PROJECT: CDMS23-00005 CDRZ23-03271
ADDRESS: 1921 GREEN VALLEY RD (194070015)
APPLICATION TITLE: Planning and Site Development Review
PROJECT NUMBER: 1056743

Subject: Geologic Peer Review / 30-Day Comments
CDMS23-00005 & CDRZ23-03271
dk Engineering (applicant)/ G. Moore (owner)
APN 194-070-018 / 1921 Green Valley Road
Alamo Area, Contra Costa County
DMA Project #3006.24

Subject: Geologic Peer Review / Revised TPM
CDMS23-00005 & CDRZ23-03271
dk Engineering (applicant)/ G. Moore (owner)
APN 194-070-018 / 1921 Green Valley Road
Alamo Area, Contra Costa County
DMA Project #3025.24

TO: Syd Sotoodeh, Planner, Department of Conservation and Development
FROM: Alex Vazquez, Associate Civil Engineer, Engineering Services Division *Cy 2025*
By: Anthony DiSilvestre, Staff Engineer, Engineering Services Division
SUBJECT: **MINOR SUBDIVISION MS23-0005**
REVISED STAFF REPORT & RECOMMENDED CONDITIONS OF APPROVAL
(George Moore/Green Valley Road/Alamo/APN 194-070-015 & -018)
FILE: **MS23-0005**

**Figure 4: CDMS23-00005 CDRZ23-03271
Liquefaction Potential Map**

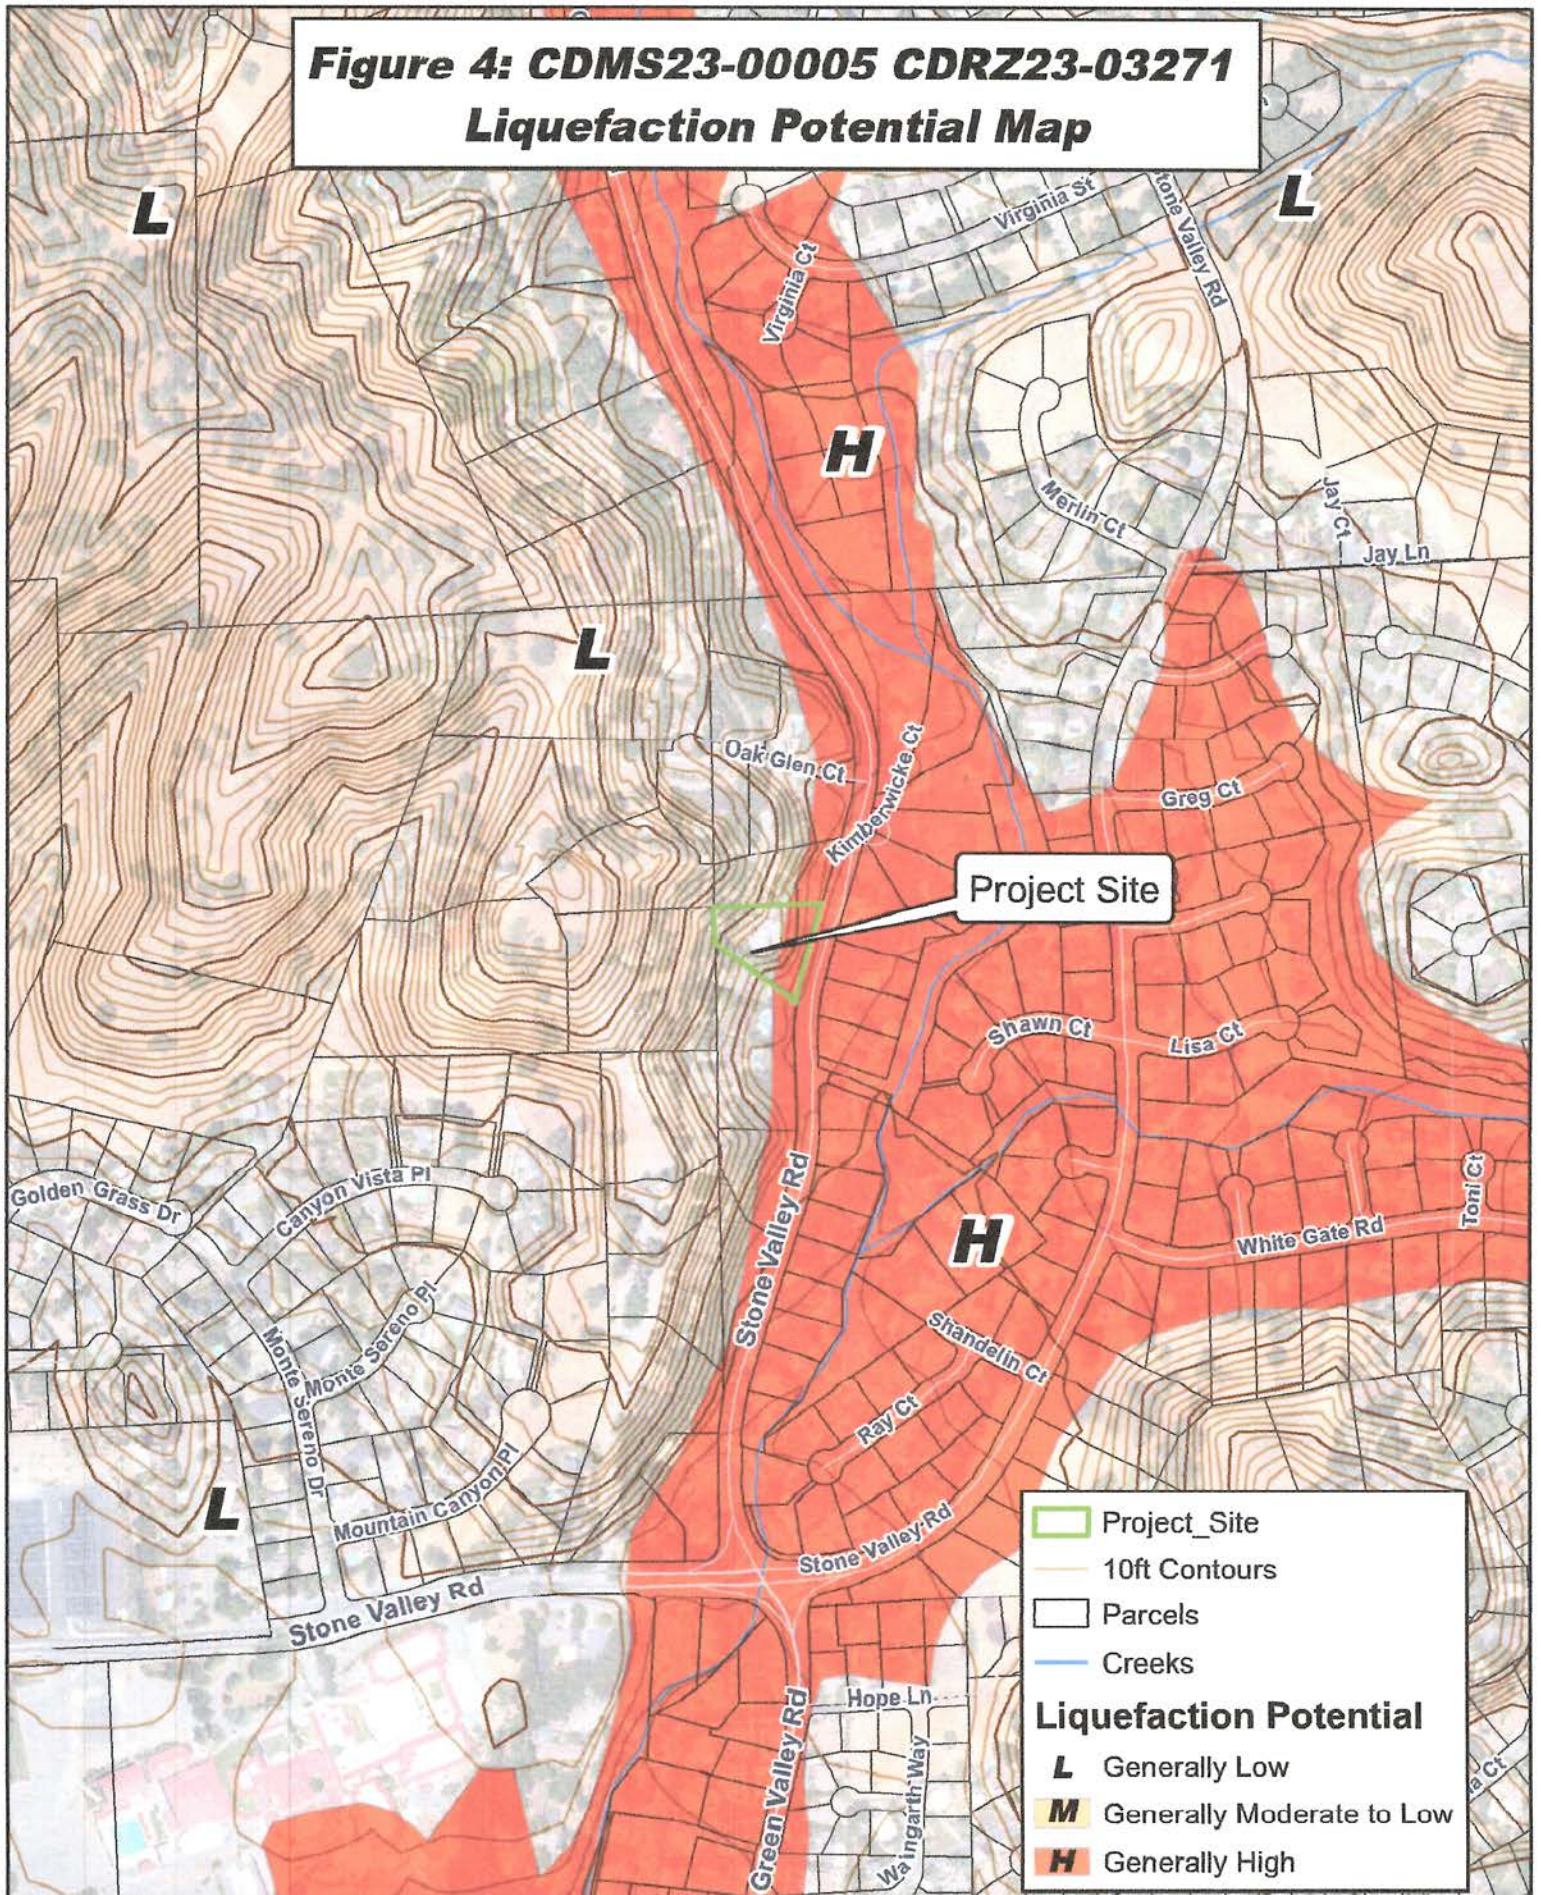
Field exploration was performed on December 4, 2023, and included the logging of five (5) auger borings (locations shown on Figure 4 of the GFK report). The borings ranged from 11½ to 26½ ft. in depth. The logs are presented in Figures 6 through 10 and show the details of the units penetrated. The logs present the classify the materials penetrated using the Unified Soil Classification System; provide SPT adjusted blow counts, as well as presenting the results of laboratory testing of soil samples retrieved from the borings.
